**Multi-Sector General Permit for Stormwater
Discharges from Industrial Facilities (MSGP)**

Compliance Evaluation Inspection Report

**P4 Production, LLC./Blackfoot Bridge Mine
(a subsidiary of the Monsanto Company.)
Soda Springs, Idaho**

**Inspection date: September 23, 2014
Report completion date: December 1, 2014**

Photo No. 1 (Map provided by P4 BFB)
BFB 2014 Stormwater Map – Updated on 10/15/2014

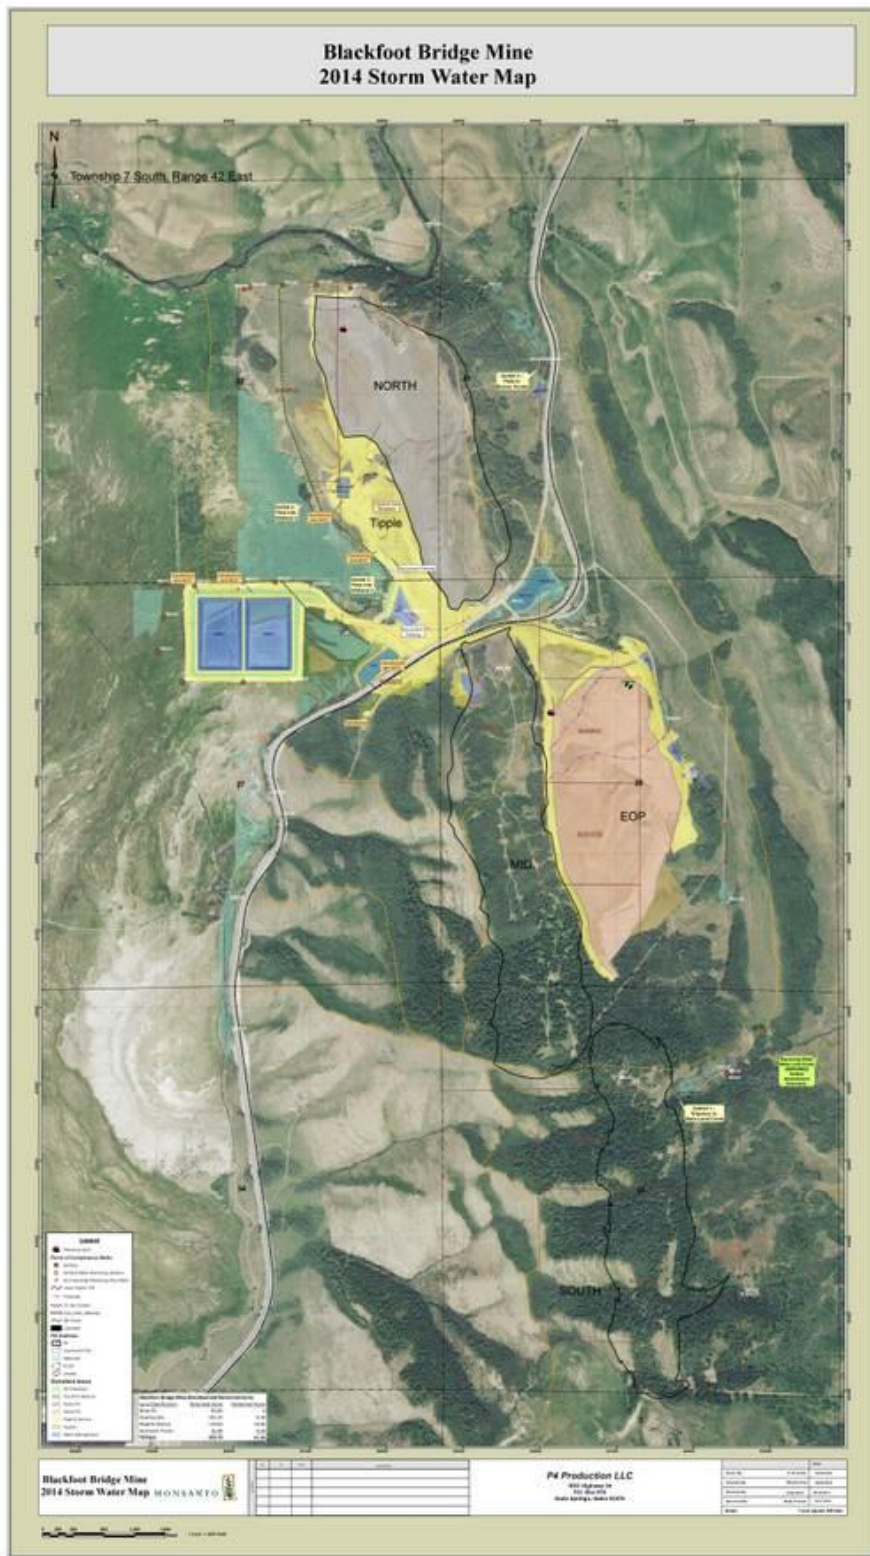
- 8) **SWPPP - Site Description and Site Map:** Part 5.1.2 of the MSGP establishes a requirement to include a site map as part of the site description in the SWPPP. In addition to other features, the site map must identify the “...locations of all existing structural control measures...”. At some point during the construction phase of the BFB mine, BFB had installed a collection sump, culverts, and a rock-lined channel to convey stormwater from the north-south haul road bisecting the central portion of the site, around the northern perimeter of the EOP, and into EP-1 (see Photos 23-25 and 29). This structural control was not shown on the site map at the time of this inspection. In his October 23, 2014 response letter, Mr. Vranes indicated that this feature was added to the map on 10/15/2014.
